**CITY OF TRINIDAD
DOWNTOWN TRINIDAD PEDESTRIAN & CONNECTIVITY
IMPROVEMENT PROJECT
RPL-5036(014)**

ADDENDUM NO. 1

The purpose of this Addendum is to modify the Contract Documents for the Downtown Trinidad Pedestrian & Connectivity Improvement Project (“Project”).

| Title | SITE & GRADING PLANS | | |

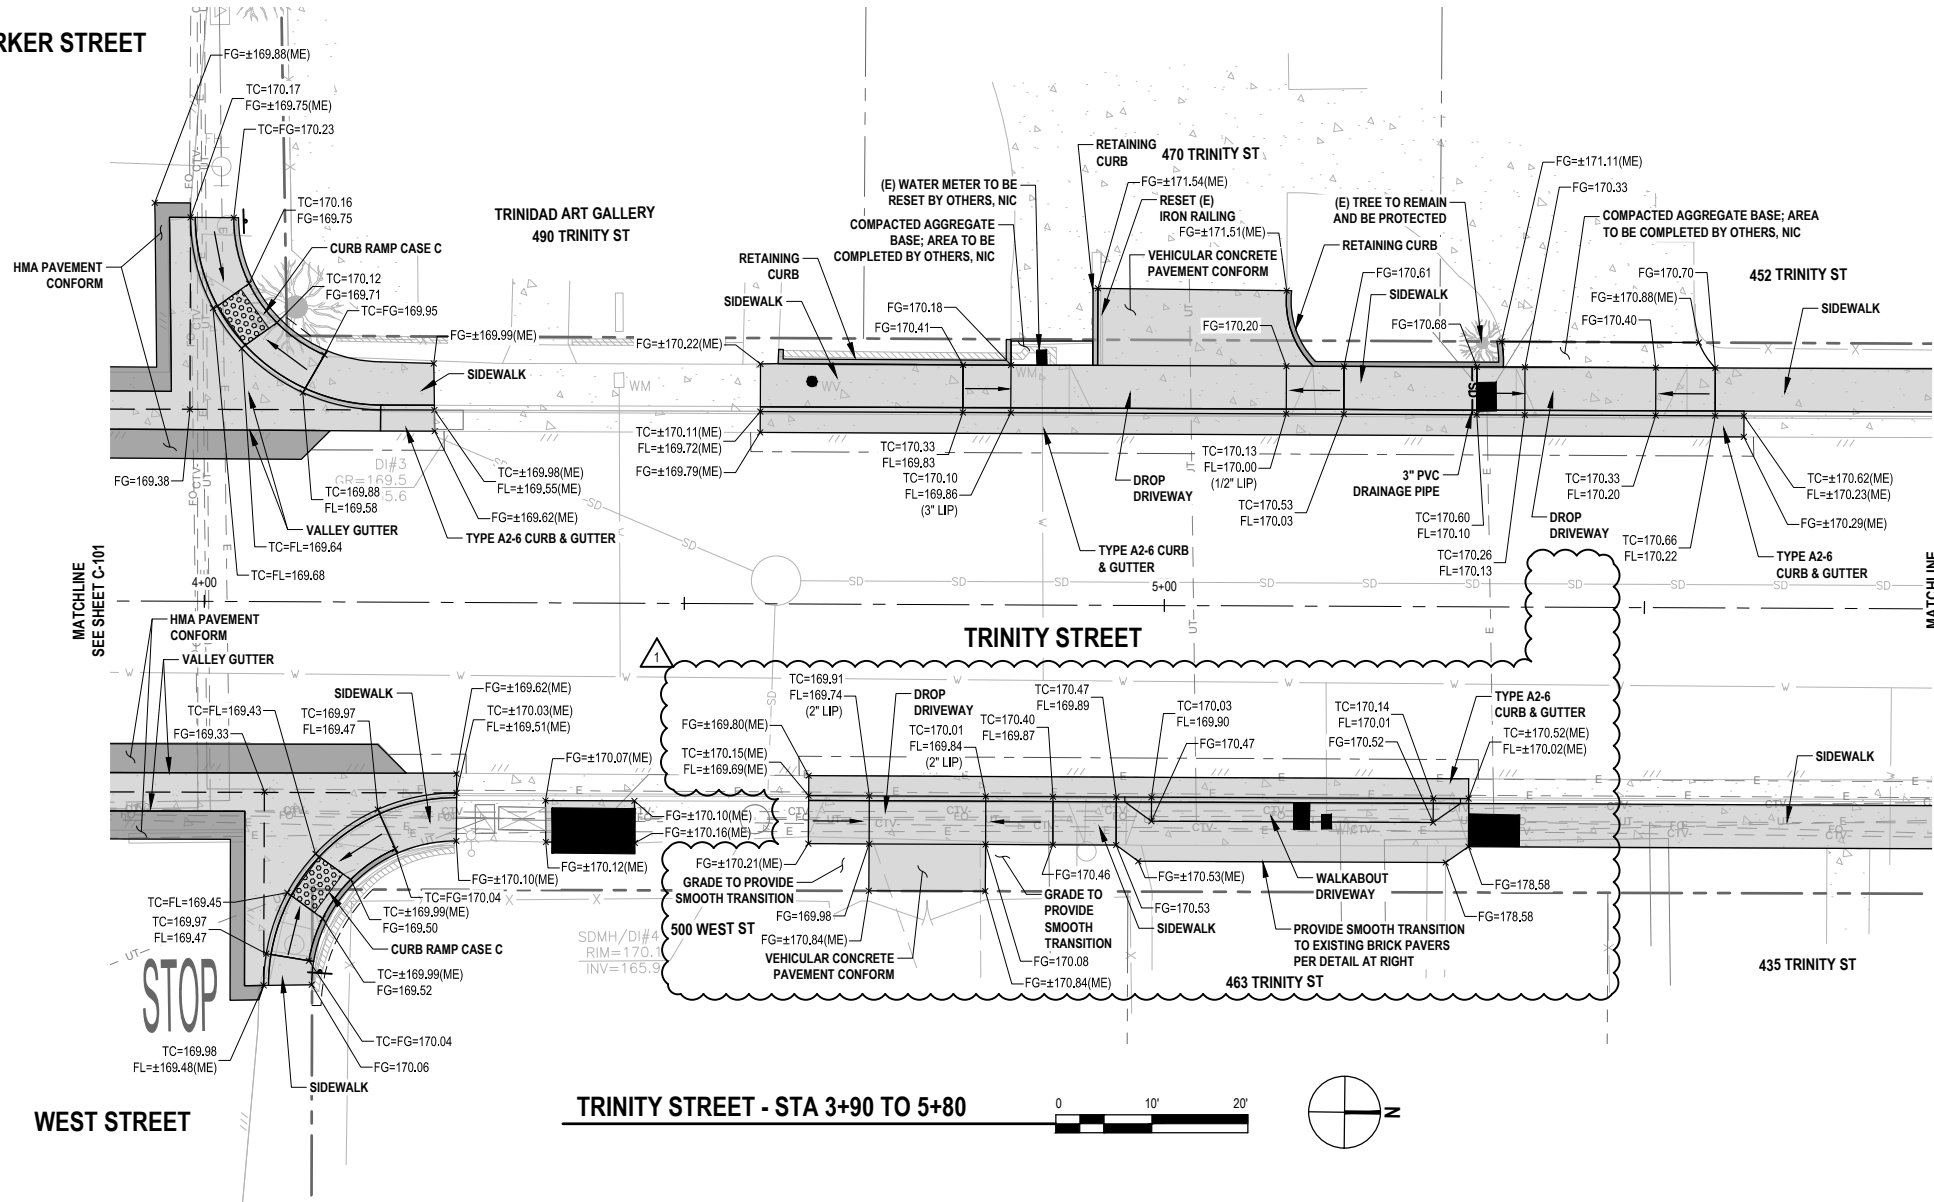
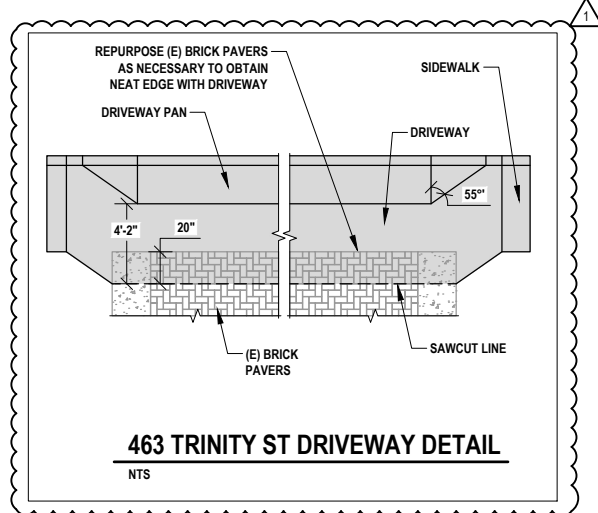
Revisions to Drawing C-102 (Sheet 7), Site & Grading Plans Trinity Street – STA 3+90 to 5+80 (see revised drawing attached):

- Revised driveways for 500 West Street and 463 Trinity Street, and added detail for driveway at 463 Trinity Street.
- Eliminated curb inlet and 12-inch storm drain.

TENNIS COURT CHAIN LINK FENCE AND GATE DETAIL

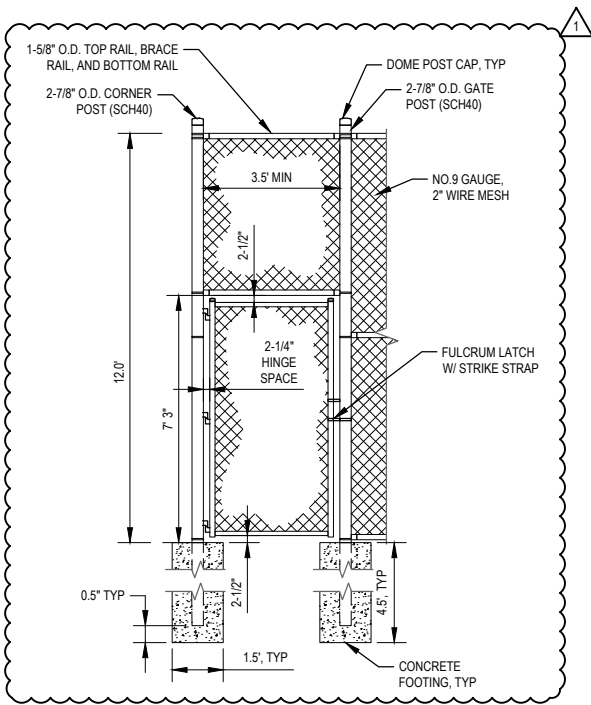
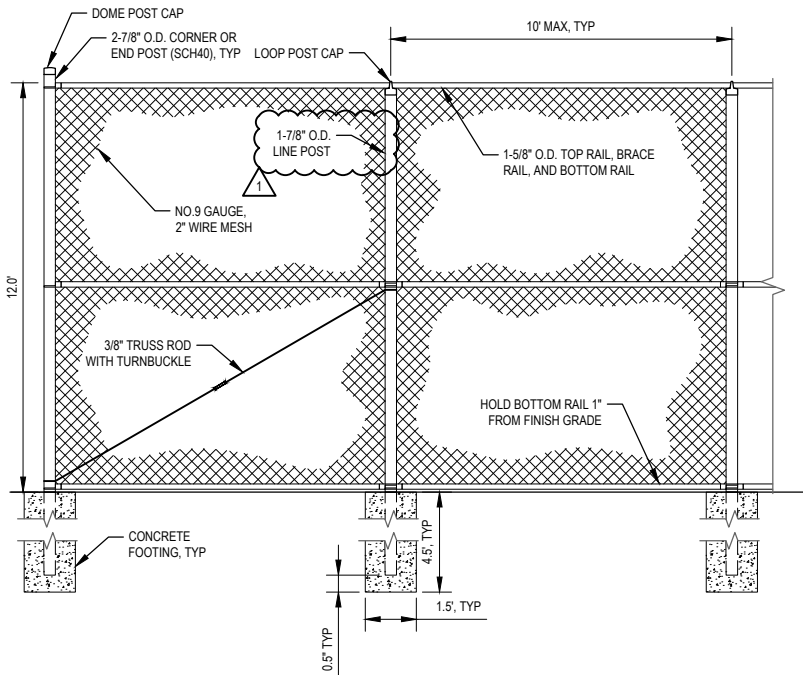
Revisions to Drawing C-501 (Sheet 12), Construction Details 1 of 4 (see revised drawing attached):

- Revised Tennis Court Chain Link Fence and Gate Detail.

DRIVEWAY DETAIL NOTES:

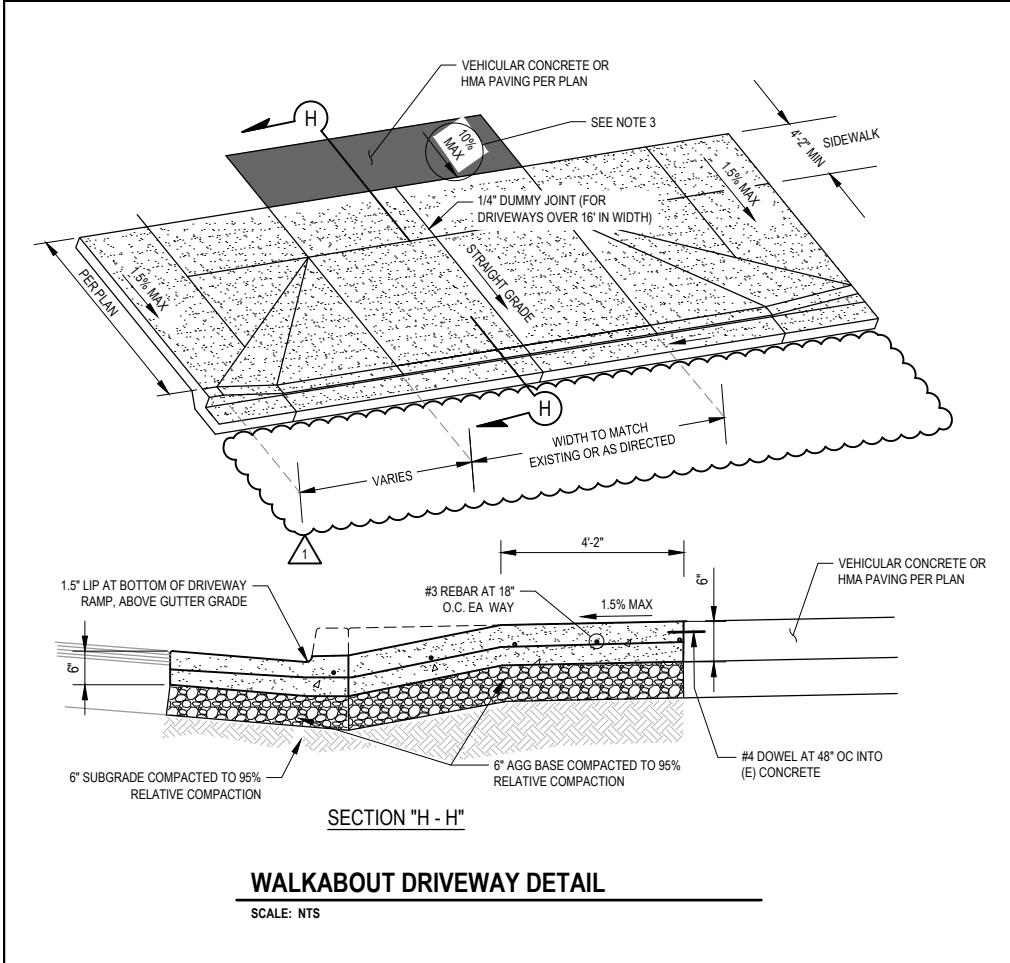
Revisions to Drawing C-504 (Sheet 15), Construction Details 4 of 4 (see revised drawing attached):

- Revised width of Walkabout Driveway Detail.
- Revised width of Bump-Out Driveway Detail.
- Revised width of Drop Driveway Detail.
